TOWN OF LEDYARD CONNECTICUT

Inland Wetland and Water Courses

~ AGENDA ~

Tuesday, August 4, 2026

SHEET 8 OF 13

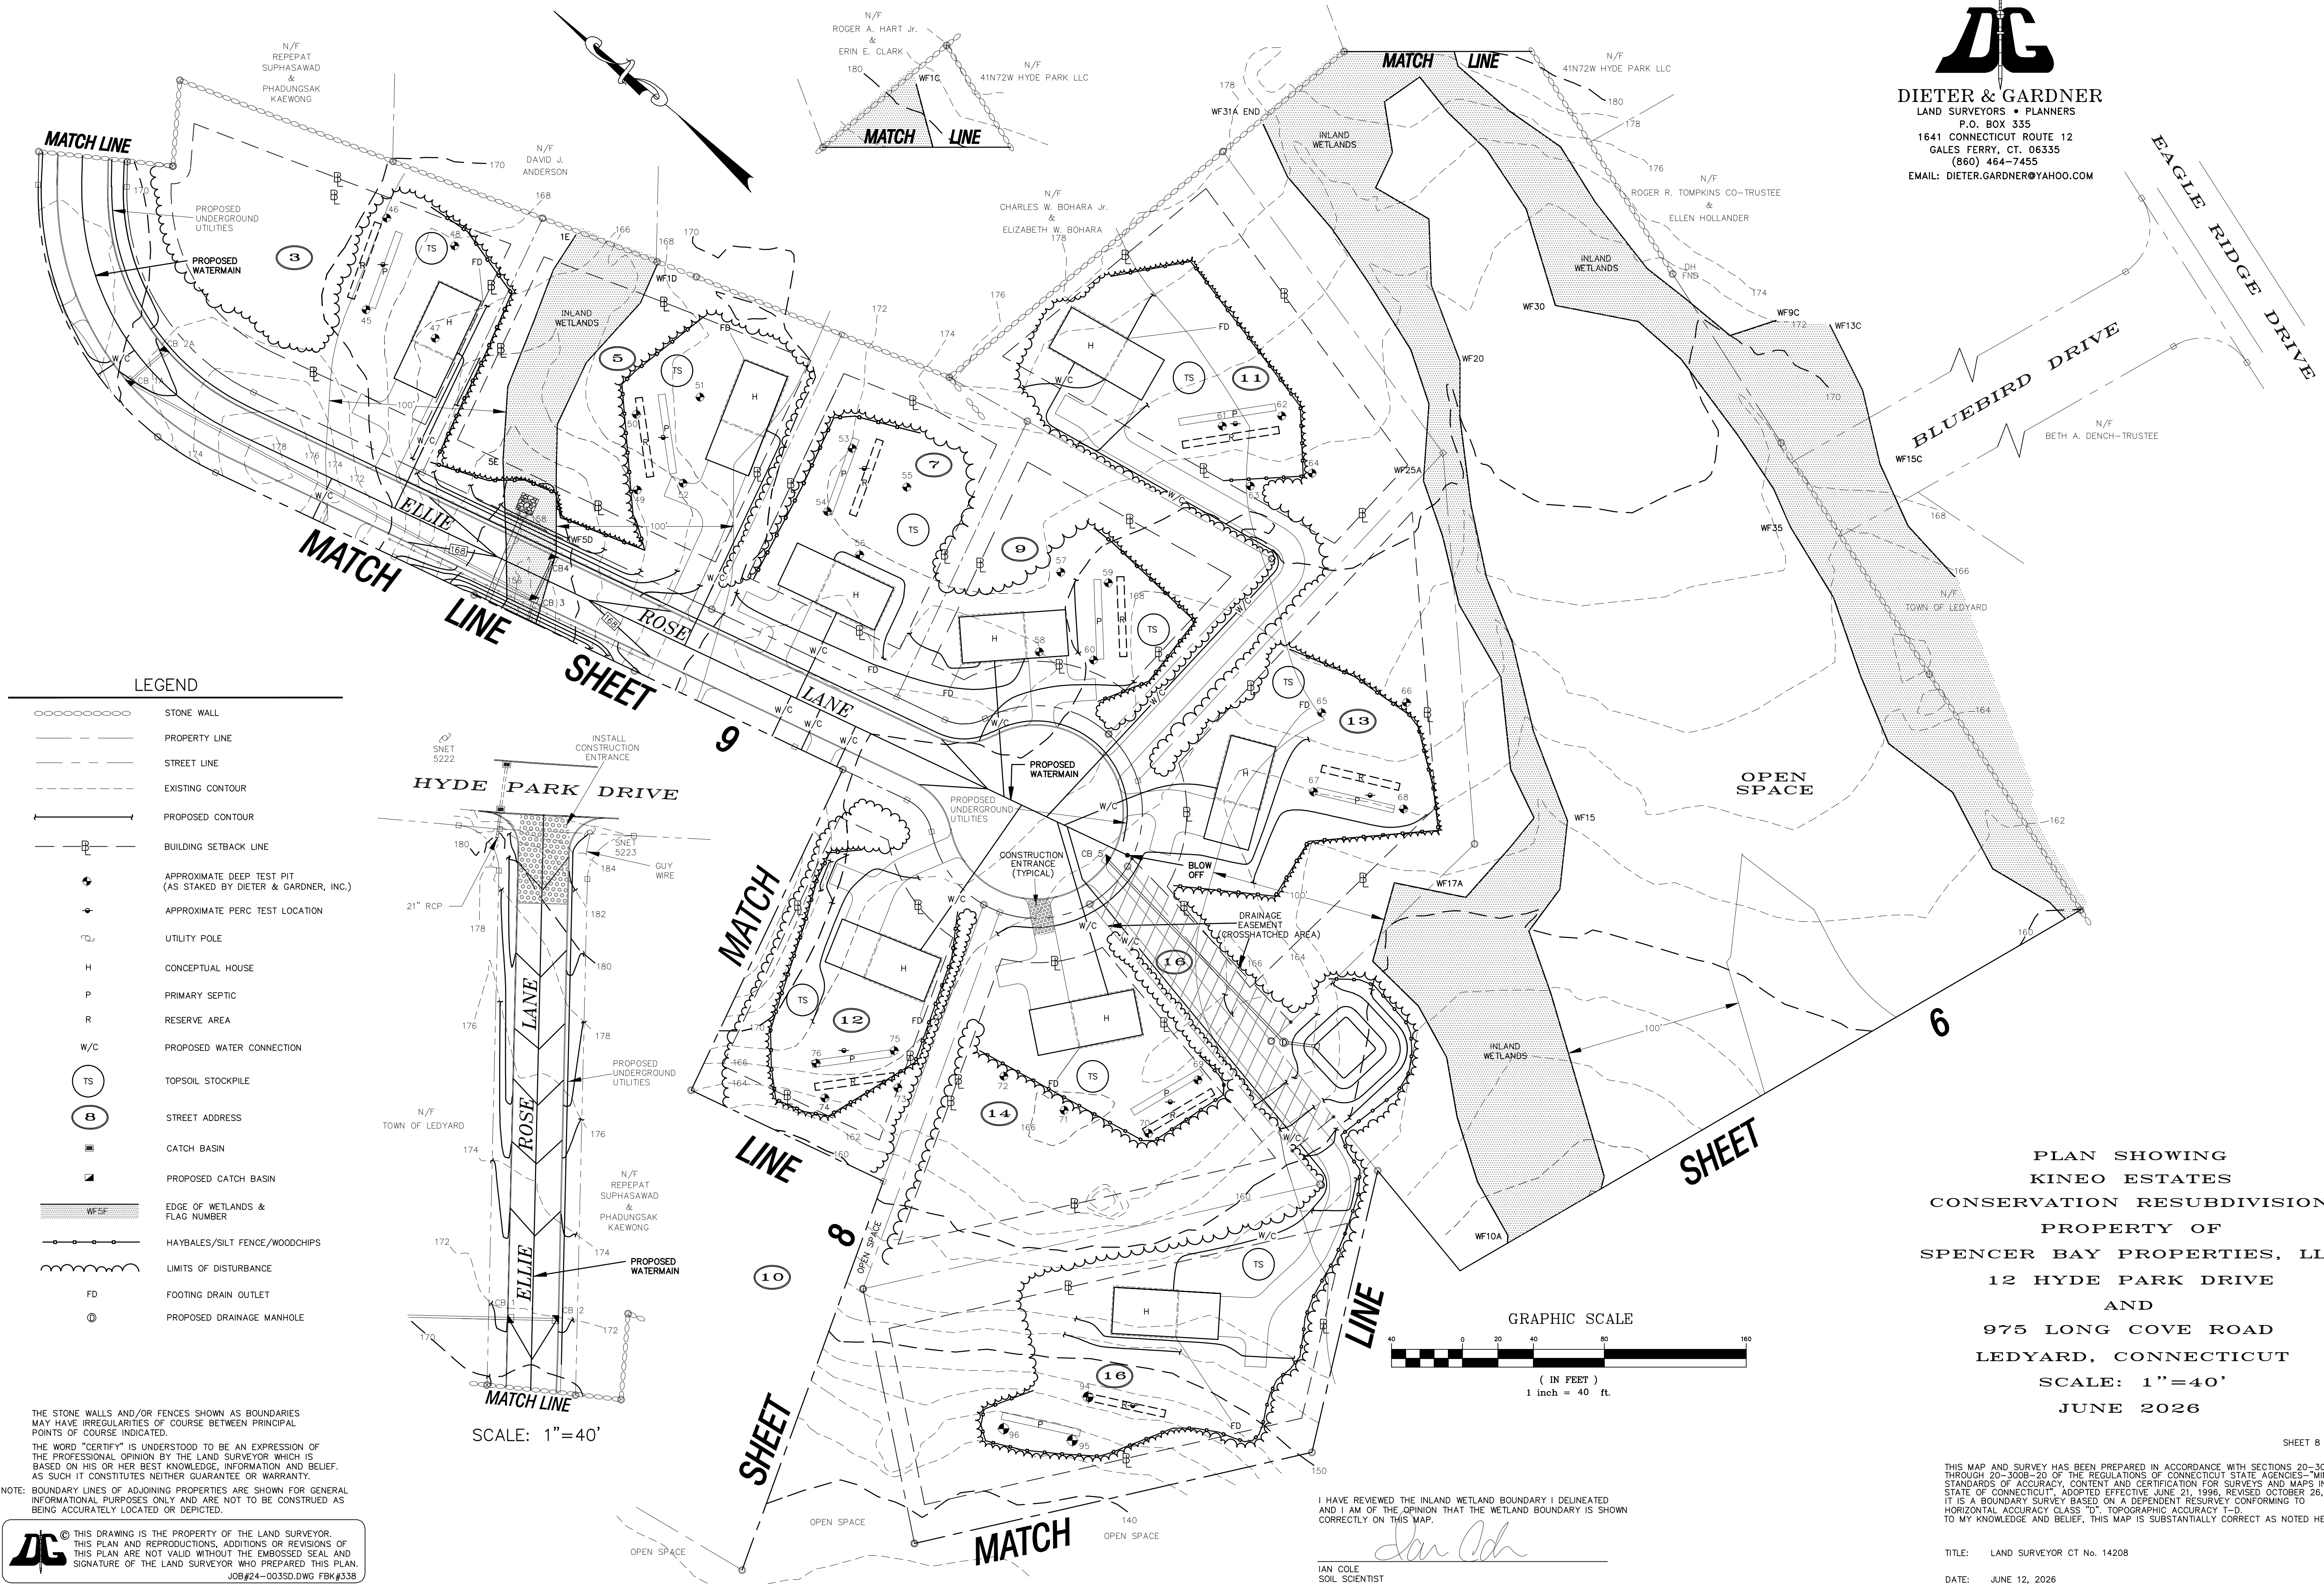
2. Sheet 10
 - a. A drainage manhole is shown receiving stormwater from CB 5 and discharging into the basin. This does not correspond to the components and calculations in the Engineering Report.
 - b. For correspondence to the provided detail, the call-out of a detail for the outlet structures at the basins downstream of CBs 1 and 5 should be "D-Box Outlet Structure."
 - c. The invert for the flared end downstream of CB 3 is not given. Also, the 20' length does not correspond to the 45' length given in the Storm Sewer System Design sheet in the Engineering Report.
